**Acoustics — Noise emitted by
machinery and equipment —
Guidelines for the use of basic
standards for the determination of
emission sound pressure levels at a
work station and at other specified
positions**

AMENDMENT 1

Acoustics — Noise emitted by machinery and equipment — Guidelines for the use of basic standards for the determination of emission sound pressure levels at a work station and at other specified positions

AMENDMENT 1

Page 11, Clause 5

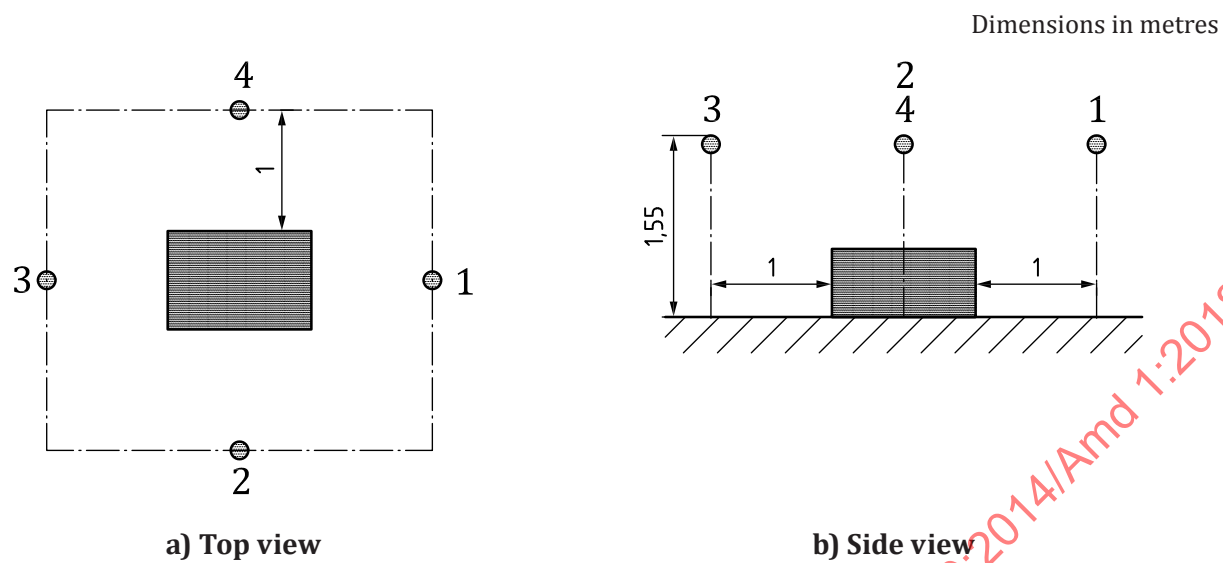
Delete the following first two lines of the text:
